# Access Compliance Report

## Public Rights-of-Way

### (Curb Ramps)

Intersection ID: 26828	Main Street: ALEXA_RD	Cross Street: OAK_POND_CR	Location: S
ADA ID: 8D352EF2DAA9	Ramp Type: PerpDiag	Initial Pass/Fail: Fail	Overall Compliance: No
		Severity Score: 25

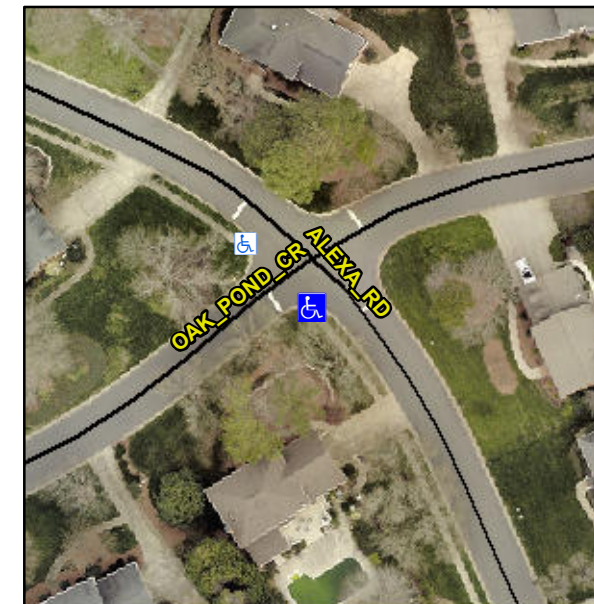
**Not Found, R304.5.3**

Compliance	Description	Data	Compliance	Description	Data
N/A	Ramp Length (in)	33.0	Yes	Ramp Slope (%)	6.8
Yes	Ramp Width (in)	48.0	No	Ramp XSlope (%)	10.6
N/A	Flare Type LT	N/A	N/A	Flare Type RT	N/A
N/A	Flare Slope LT (%)	N/A	N/A	Flare Slope RT (%)	N/A
N/A	Flare Traversable LT?	N/A	N/A	Flare Traversable RT?	N/A
N/A	Landing Length (in)	N/A	N/A	DWS Provided?	N/A
N/A	Landing Width (in)	N/A	N/A	DWS Contrast?	N/A
N/A	Landing Slope (%)	N/A	N/A	DWS Length (in)	N/A
N/A	Landing X Slope (%)	N/A	N/A	DWS Full Width?	N/A
N/A	Landing Curb? (Y/N)	N/A	N/A	DWS Offset (in)	N/A
N/A	Shared Landing?	N/A			
N/A	Gutter Ponding?	N/A	N/A	Gutter Slope (%)	N/A
N/A	Gutter Lip Ht (in)	N/A	N/A	Gutter X Slope (%)	N/A
N/A	Painted X Walk1?	No	N/A	Painted X Walk2?	No
	X Walk 1 Direction	To NE		X Walk 2 Direction	To NW
N/A	X Walk 1 Width (in)	N/A	N/A	X Walk 2 Width (in)	N/A
	X Walk 1 Slope (%)	5.9		X Walk 2 Slope (%)	0.5
	X Walk 1 X Slope (%)	4.3		X Walk 2 X Slope (%)	6.6

**Remove & Replace Curb Ramp With Two New Directional Ramps or Equivalent.**
